Features and Benefits

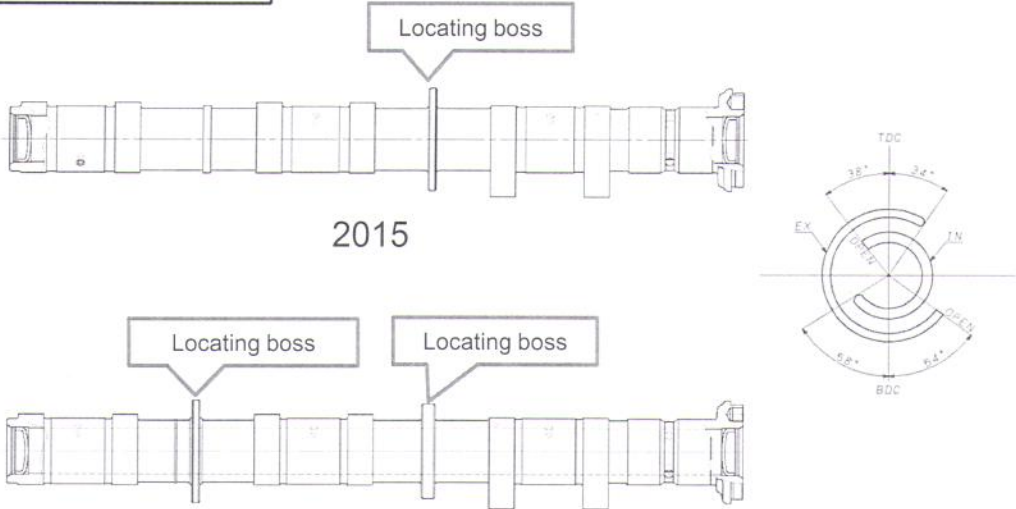
Item	Description
<p>Engine</p> <p>Application: All SRViper models, except early-build</p>	<ul style="list-style-type: none"> • New Camshaft ✓ New locating boss. ✓ Valve timing remains unchanged. ✓ New cam timing procedure, refer to service manual. <div style="text-align: center;">  <p>2015</p> <p>2016</p> </div>

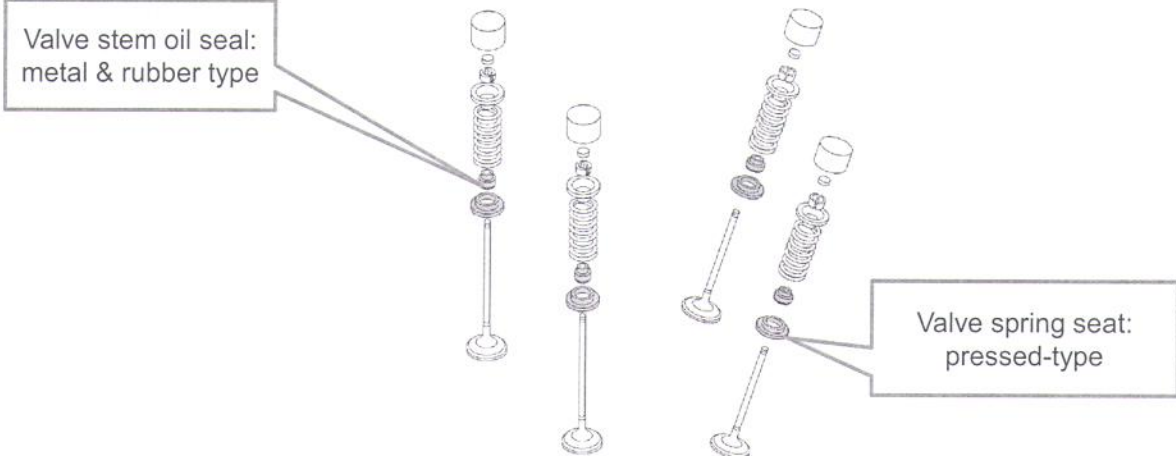
Item	Description
<p>Engine</p> <p>Application: All SRViper models, except early-build</p>	<ul style="list-style-type: none"> • New Valve Stem Seals and Valve Spring Seats ✓ Valve stem seals have gone from all-rubber type to rubber with steel reinforcement. ✓ Manufacturing process changed from machining to press type. ✓ Supplier of intake and exhaust valves have changed but specification remains the same. <div style="text-align: center;">  <p>Valve stem oil seal: metal & rubber type</p> <p>Valve spring seat: pressed-type</p> </div>
